Proposed Revisions to a Standard Plans Index

Index Number: 521-510

Index Title: CONCRETE BARRIER/NOISE WALL (8'-0")

LAST REVISION	DESCRIPTION:		FY 2023-24 STANDARD PLANS	CONCRETE BARRIER/NOISE WALL (8'-0")	INDEX	SHEET
11/01/19	11/01/23				521-510	1 of 5

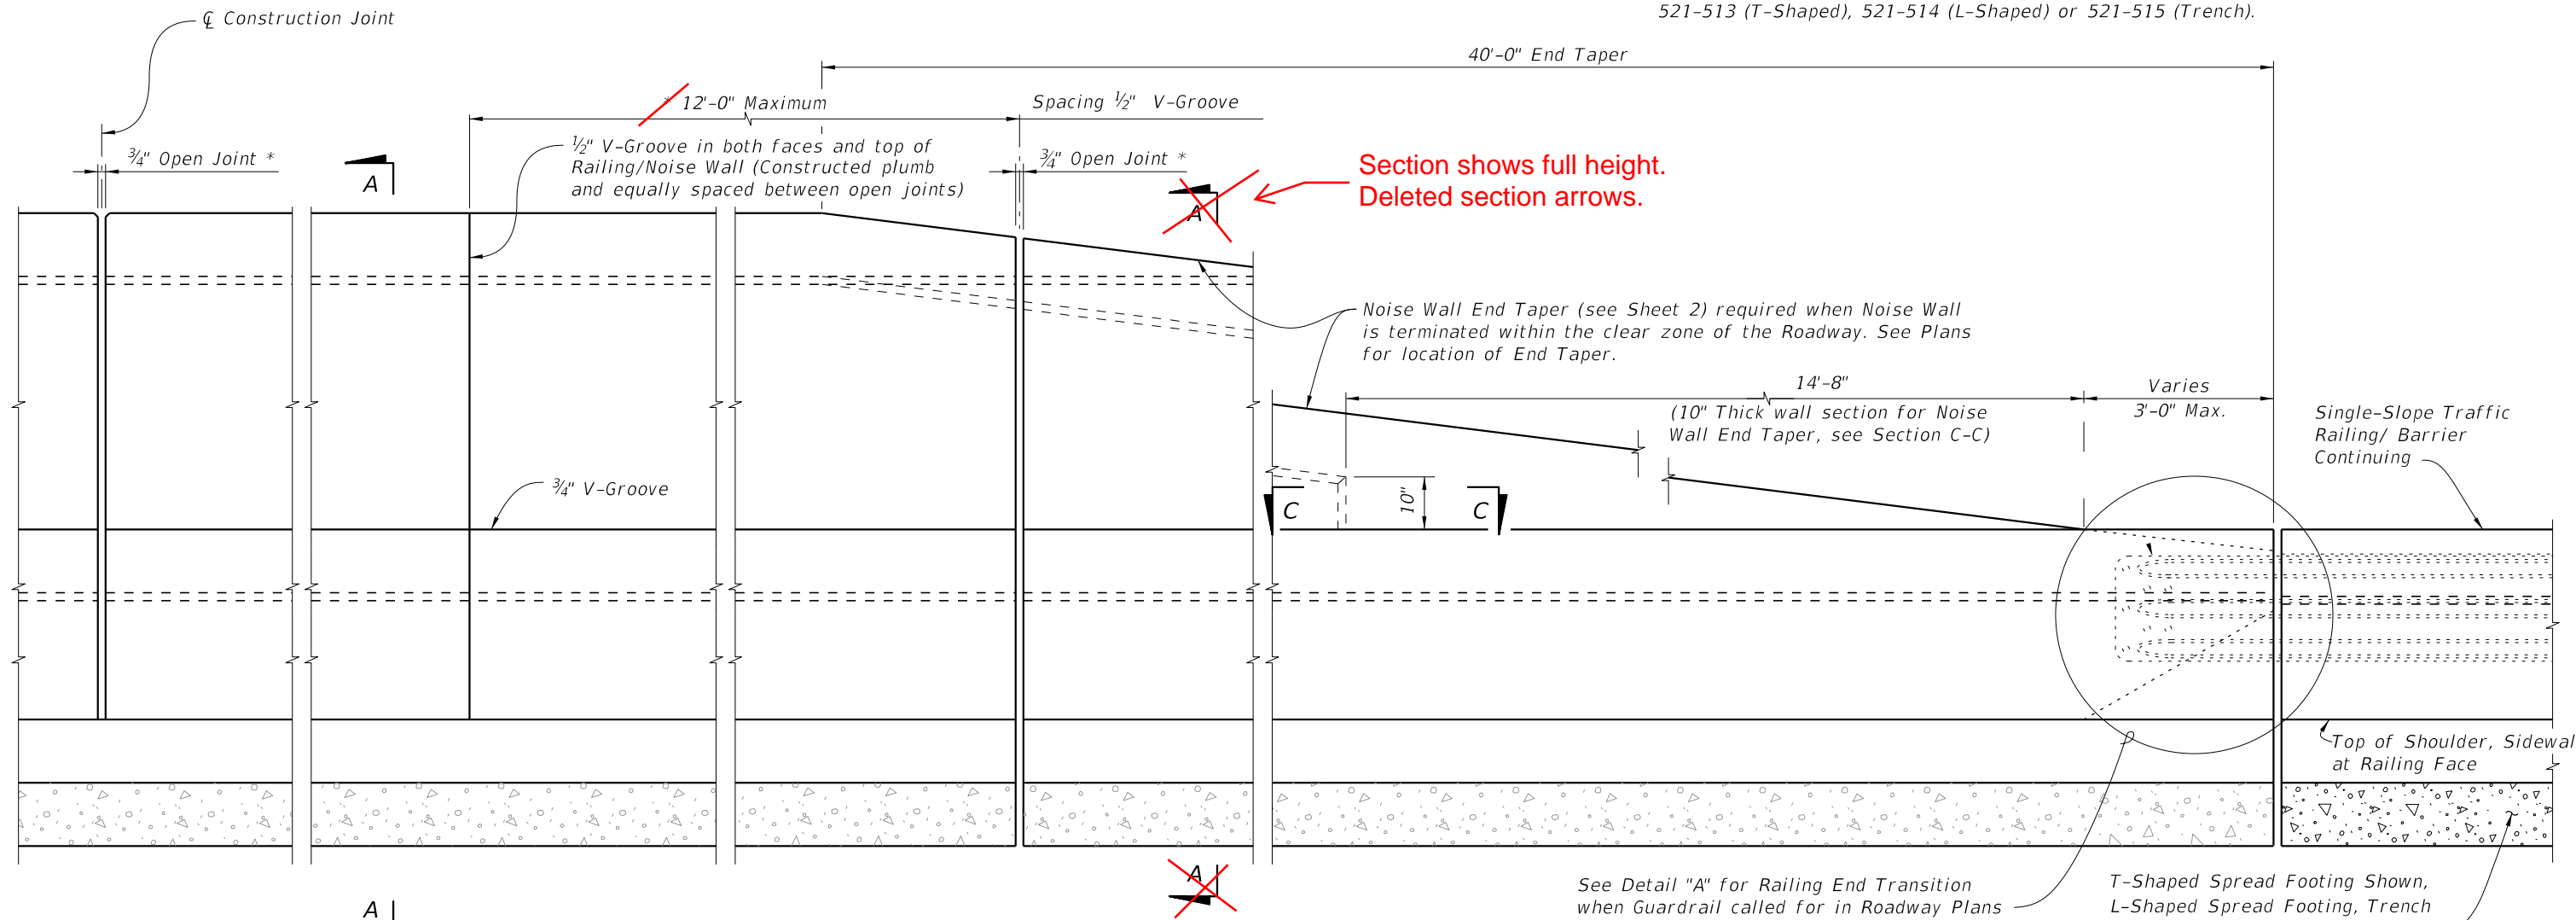
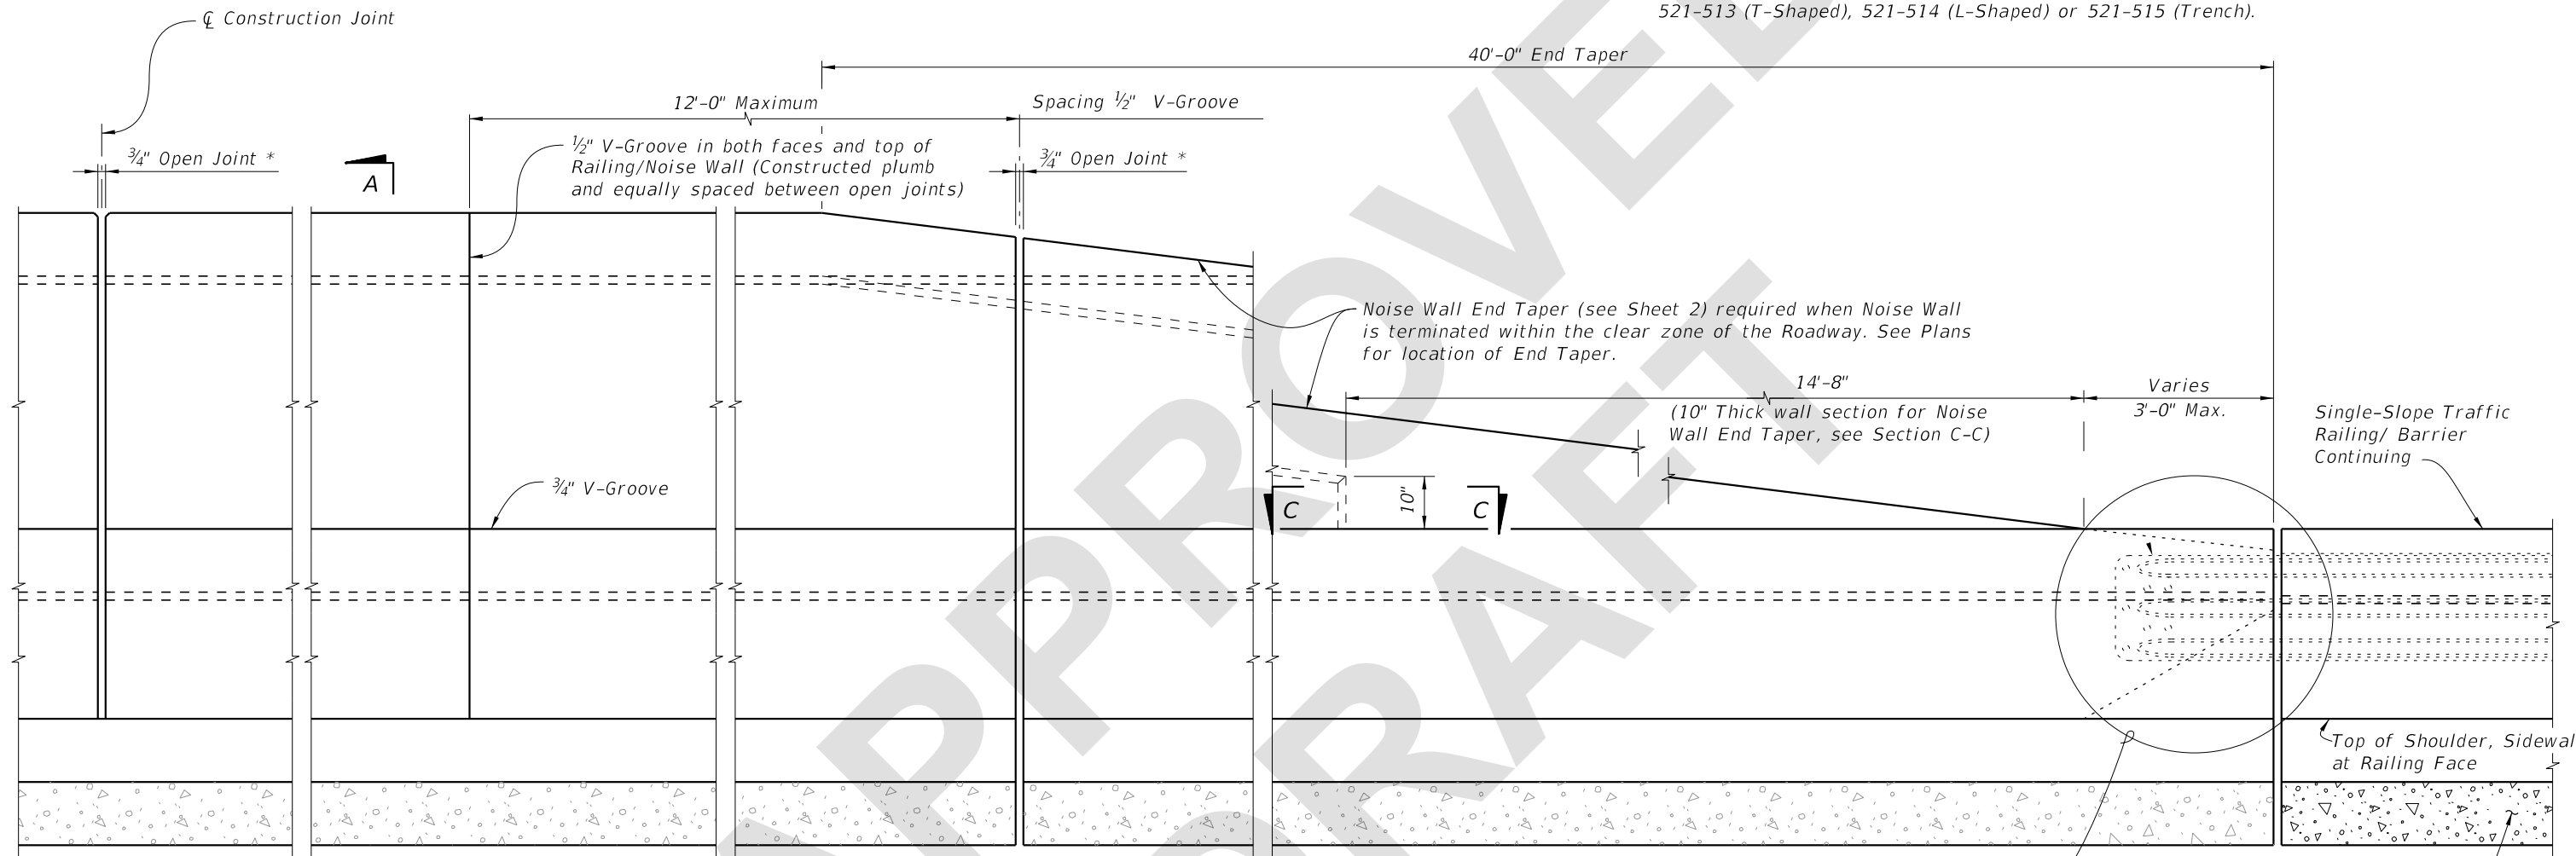
Sheet 1: Deleted section cut lines A-A.

INDEX 521-510	SHEET 4 of 5
------------------	-----------------

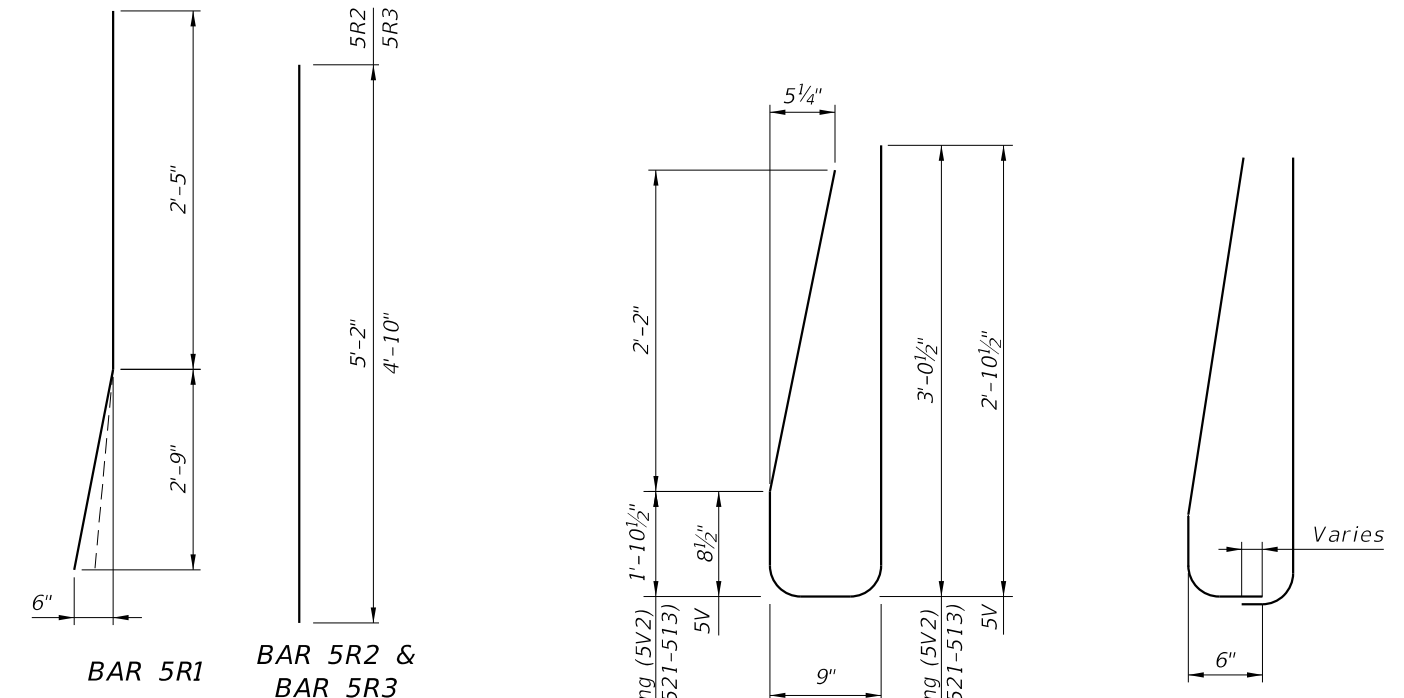
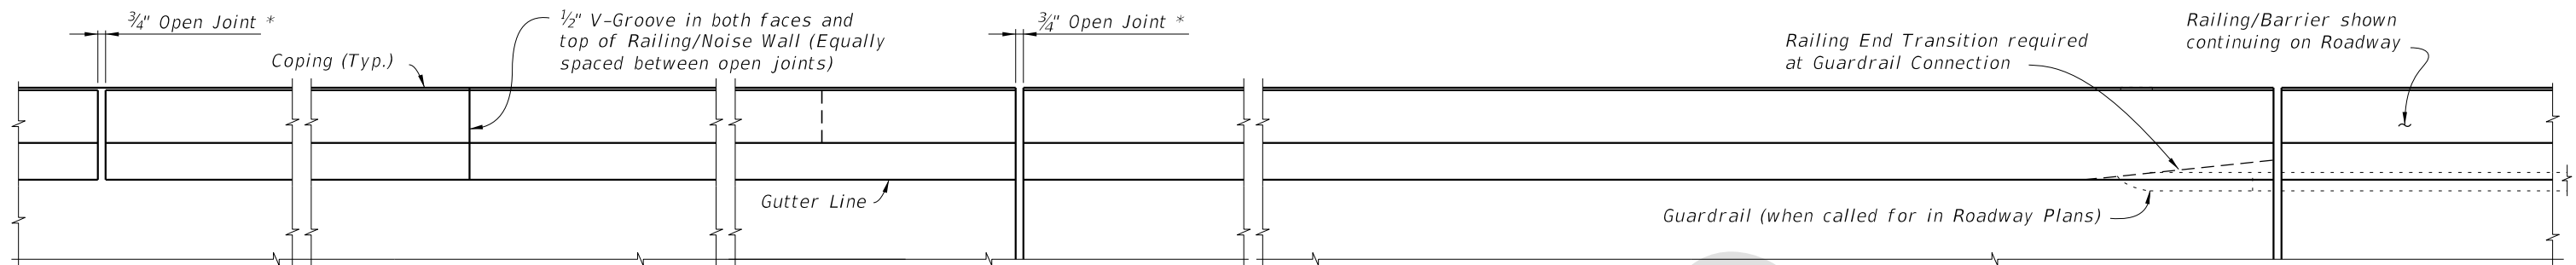
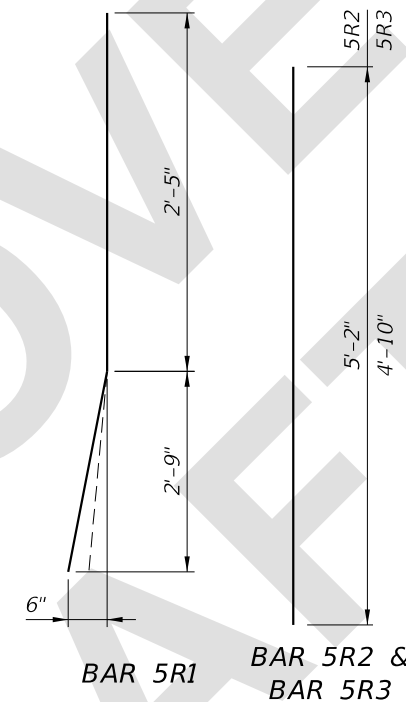
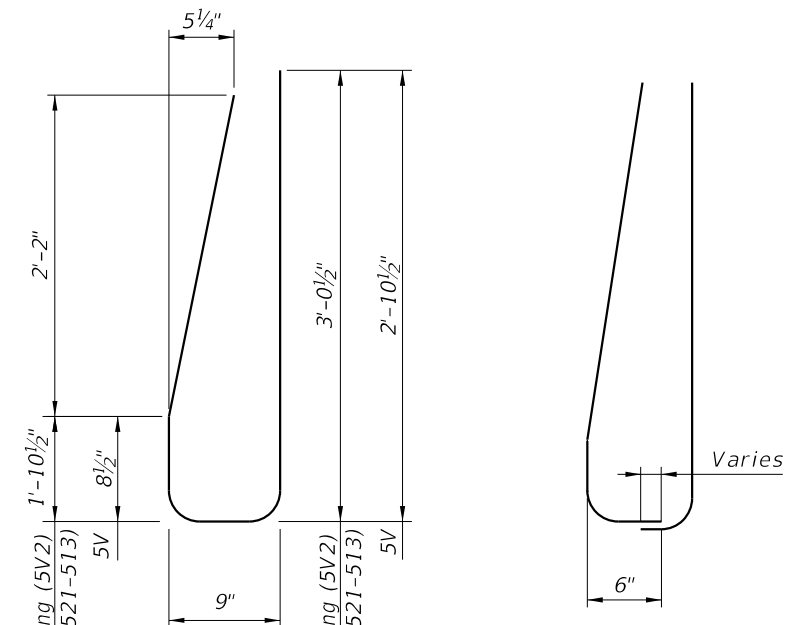
Sheet 4: Corrected reinforcing steel estimated quantities.

The estimate for reinforcing steel was slightly off for the CIP version. We updated the estimate.

CHANGED TO:
81.55
241.58

ESTIMATED TRAFFIC RAILING/NOISE WALL QUANTITIES		
ITEM	UNIT	QUANTITY
Concrete (Railing)	CY/LF	0.107
Concrete (Noise Wall)	CY/LF	0.136
Reinforcing Steel (Typical)	LB/LF	81.55
Additional Reinf. @ Open Joint	LB	241.58
